## REMARKS

Howrey Docket No.: 03079.0003.NPUS00 Application No. 10/511,014

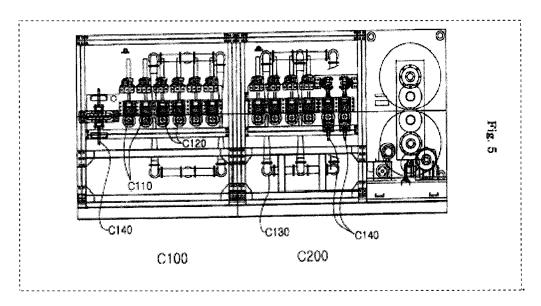
At page 2 of the Office Action, the Examiner rejects Claim 3 under 35 U.S.C. §112, ¶1, claiming there is insufficient support in the specification for the limitation requiring "continuing to apply pressure to the composite mat while cooling the same." However, Applicant respectfully submits, that position is incorrect because there is ample support in the specification for this limitation.

In particular, Fig. 5, reproduced below, shows cooling zones C100 and C200 in a system according to the invention, including magnet rollers C110 cooled for foaming the composite mat, and cooling rollers C120. (*See* specification, page 19, lines 26-28).
